Wilmington Harbor, North Carolina
Wilmington Harbor Navigation
Improvement Project
Integrated Section 203 Feasibility Study
and Environmental Report

APPENDIX S
Quality Control Report

February 2020

Figure 1. Relationship between nitrate + nitrite as nitrogen concentration and discharge for the Amite

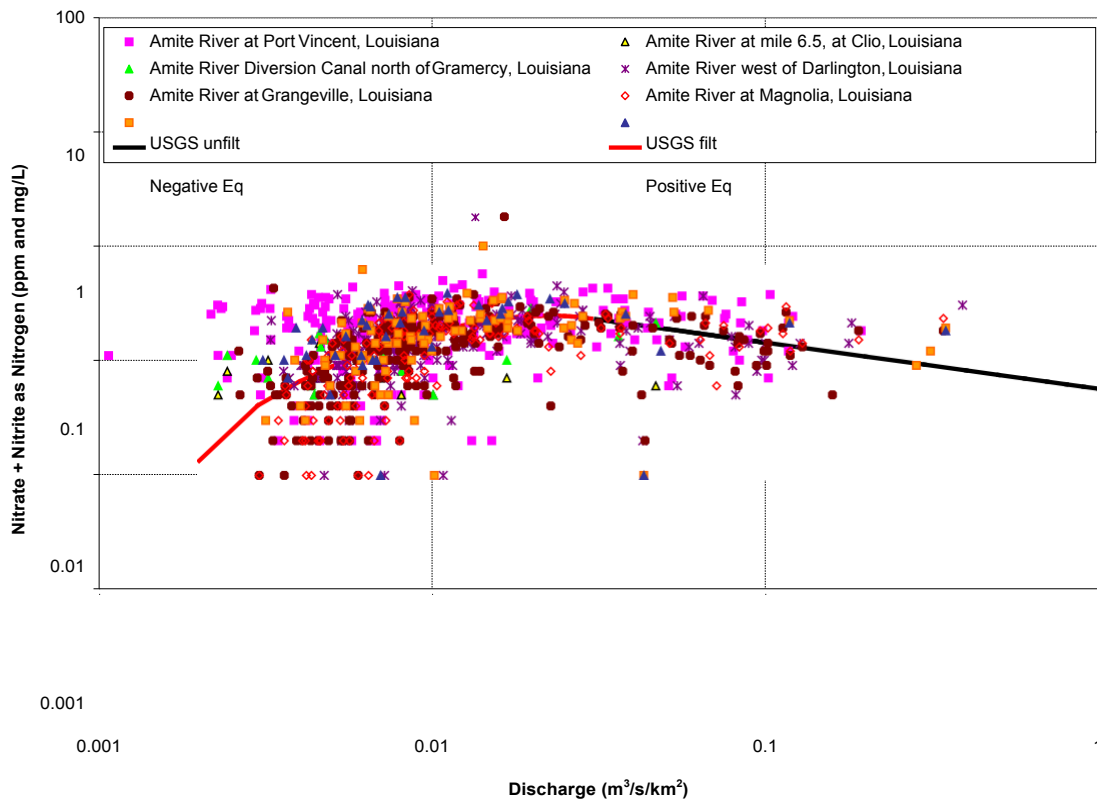
P 24 etc. Tributary loading: It is assumed that Water Quality concentrations are constant in the streams, i.e. they do not vary with the runoff. This appears to be a possible source of uncertainty in the results since at all but one of the basins there is a strong runoff event during the calibration period. Figure 1 from Roblin (2008) shows a typical response of N-NO₃ to Runoff for the Amite River in the Pontchartrain Estuary (Louisiana).

P 43-44 Figure 15: The flood events during the late summer calibration period may have produced a higher N loading in some of the tributaries (see the flow effect in Figure 1.)

Figure 2. Extract from Calibration Results.

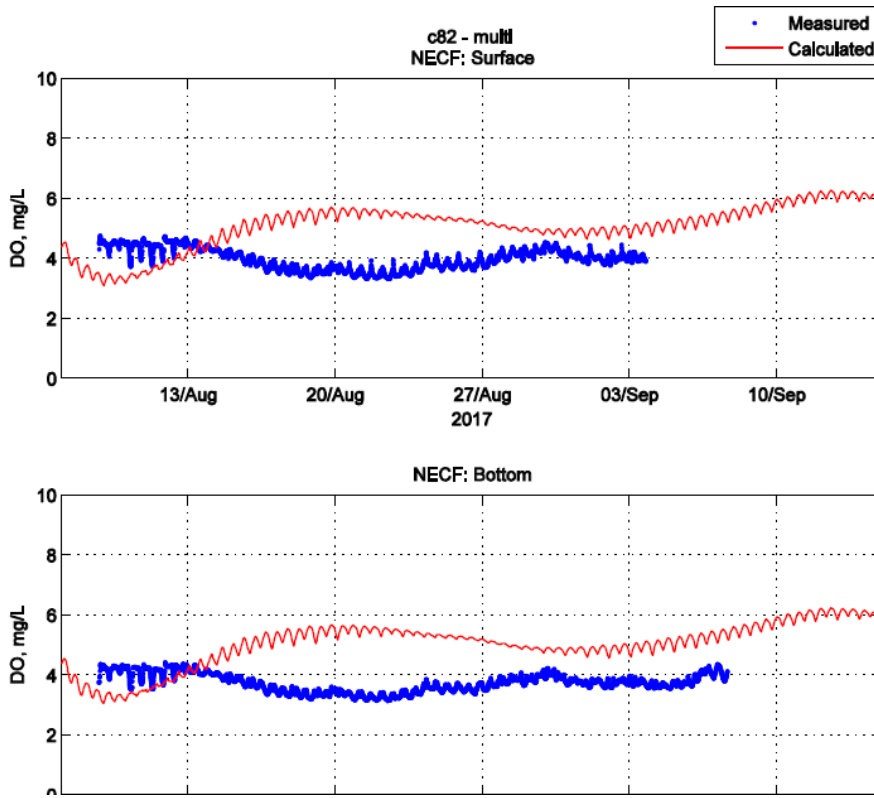
Some of the model results and continuous DO records appear to be both over-estimated and out of phase (see example Figure 2.) Is there an explanation for the out of phase effect? For example, is this a storm runoff effect due to increased organic loading?

Figure 3. Surface and bottom temperatures.

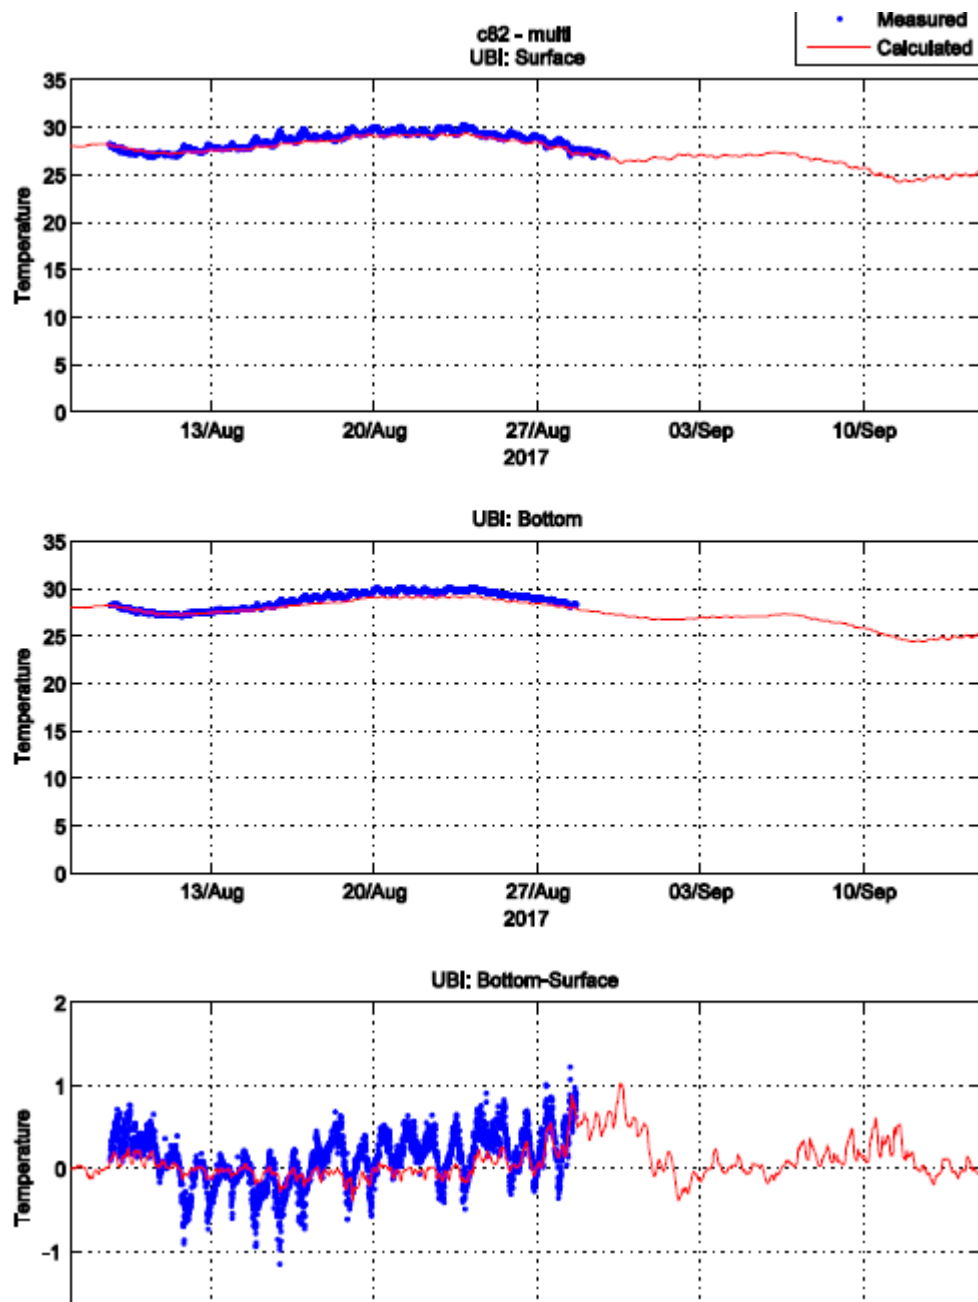
The model does a good job of simulating the mean water temperature but it seems to miss the diurnal temperature stratification (for example Figure 3). Is there an explanation for this? For example, does the model have too much numerical diffusion in the vertical or is this the result of the changes in the relative importance of long wave and short wave radiation during a 24-h period?

Figure 4. Surface and bottom DO

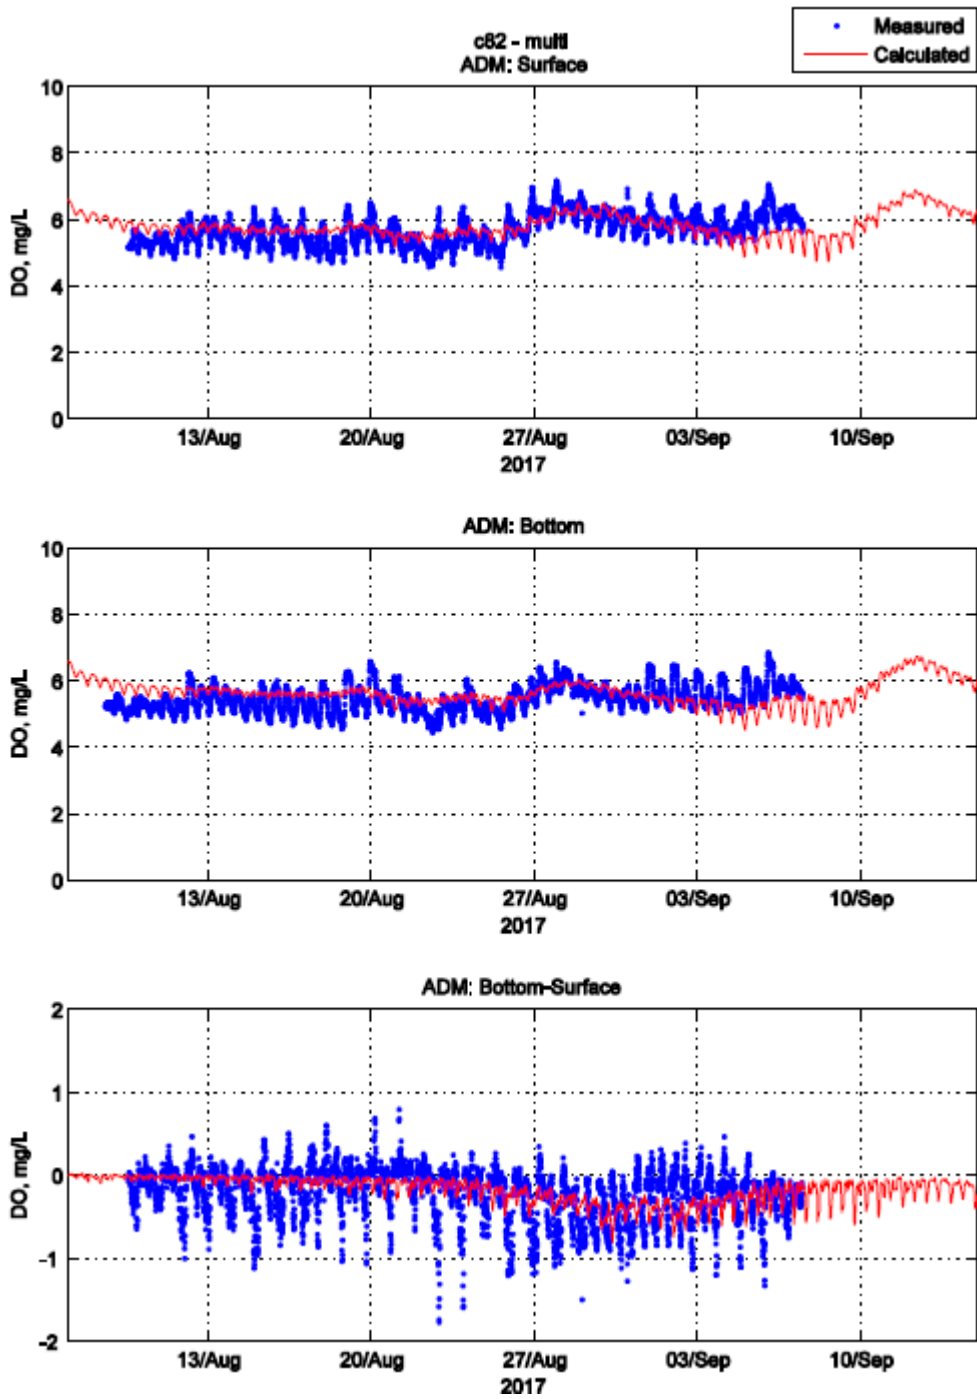
A similar smoothing effect is observed in the DO results (see for example Figure 4.) Both the observed surface and bottom DO show roughly diurnal variations as expected but these are smoothed out in the model. What is the explanation? It is interesting that the Bottom-Surface seems to have semi-diurnal period? Maybe the tidal boundary condition could be included in the report.

Figure 5. Semi-diurnal fluctuations?

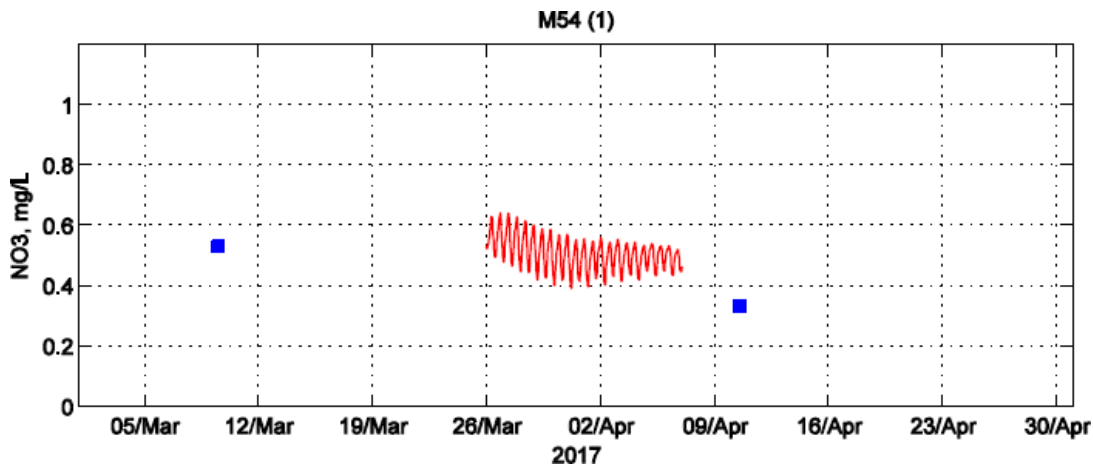
P 167 e.g.: Are the roughly 12 h fluctuations shown in several outputs, due to tides? See for example Figure 5.

Figure 6. Salinity Stratification.

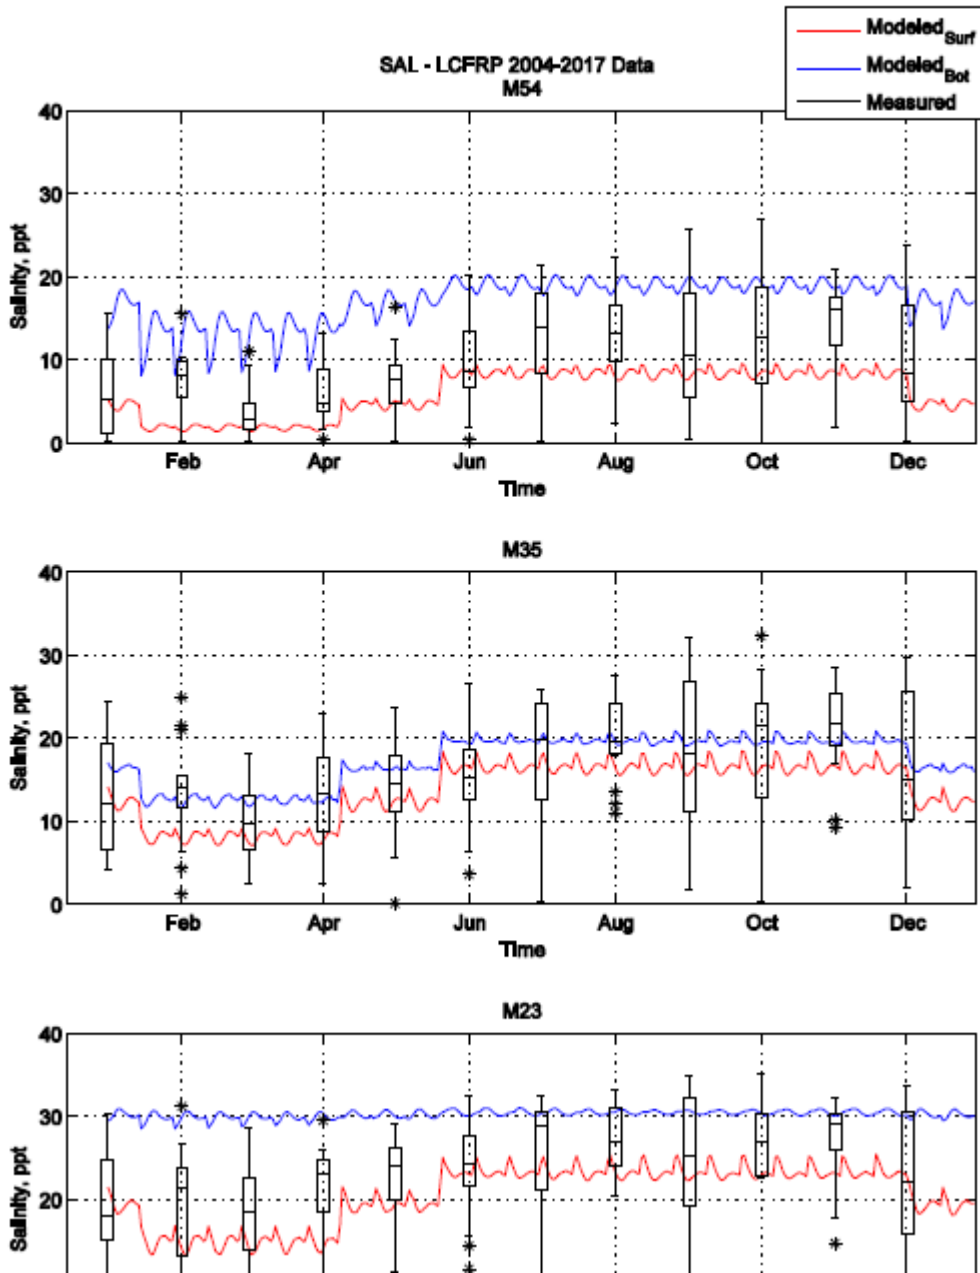
Appendix C. Long term runs: Where was the salinity measured in the water column (for example, in Figure 6 from page 250 of the report?) The model is showing strong stratification but is difficult to see if the same effect is present in the measured data.

Figure 2-2. Mean Annual Discharge at USGS Gage Stations on the Cape Fear River, Northeast Cape Fear River, and Black River.

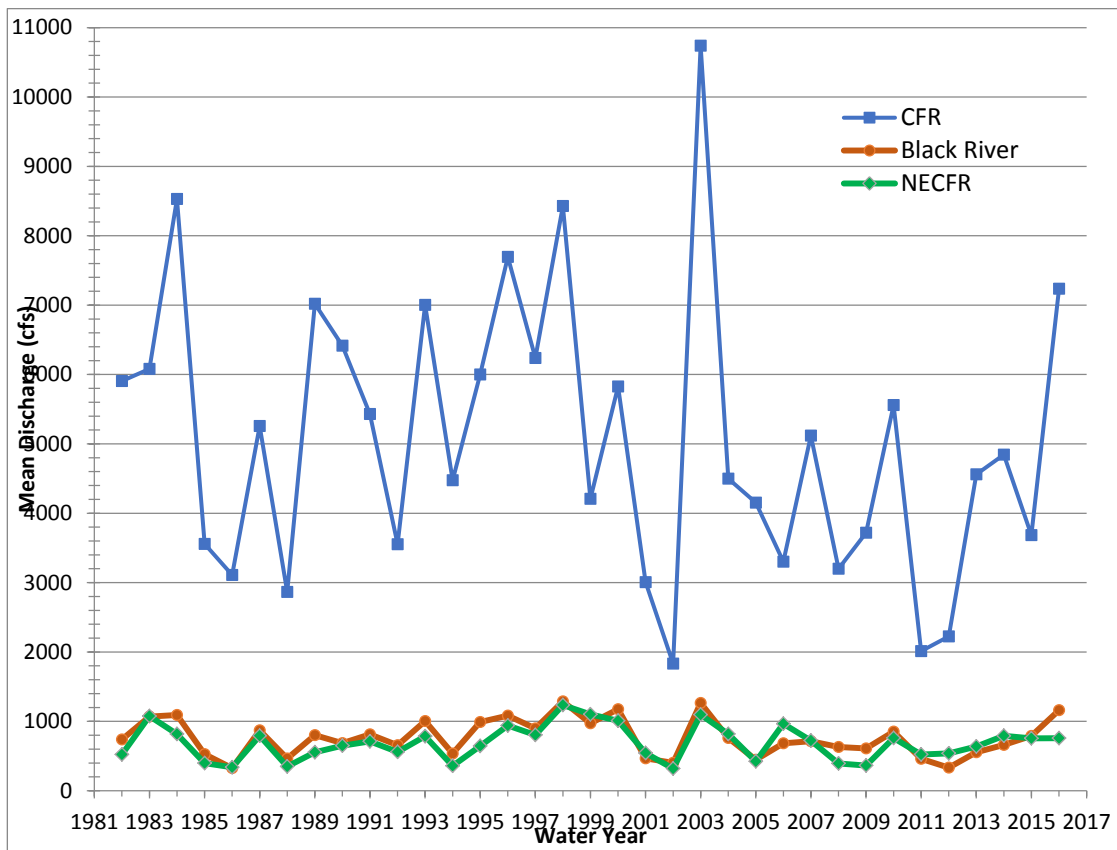
Please present these data on a graph. Seeing graphical data trends will be more meaningful than the current table.

Response: Graph has been added.
